Revision notes:

Hotel

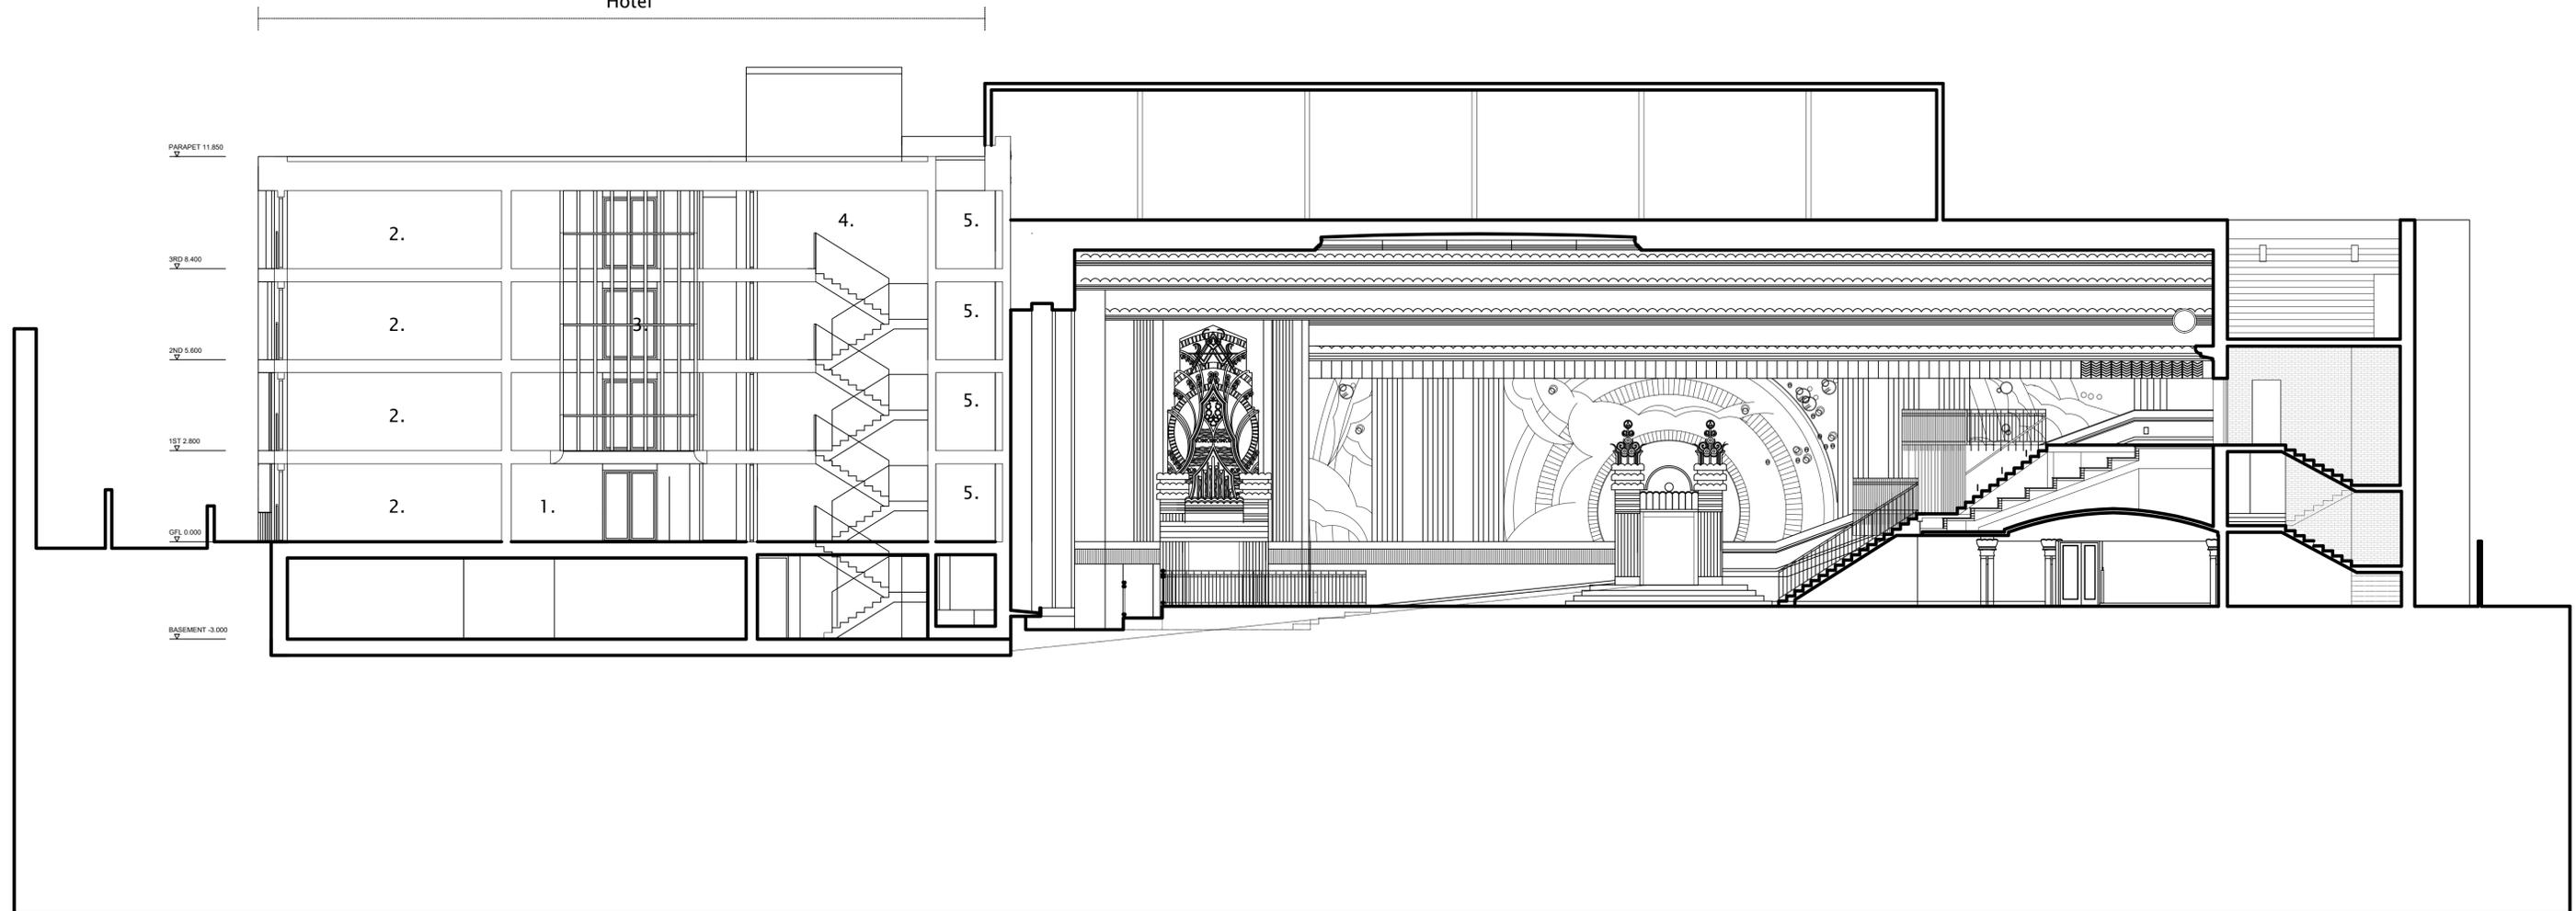
1. Basement redesigned and access flipped as requested. Access is via road at Cumbrian way.
2. Ramp has been removed and a car lift proposed. This offers more space in the basement and better turning capacity. In addition the ramp access has been removed from the front elevation.
3. Trees shown for BNG.
4. Hotel rooms revised to be Part M compliant.
5. Lift to frontages of hotel and listed building.
6. Soft landscaping and terracing to front of hotel.
7. Pathways and alley improved with landscaping.
8. Oriel windows added to the southern elevation to mitigate overlooking.
9. Low energy systems added to roof.
10. Window head detailing added.
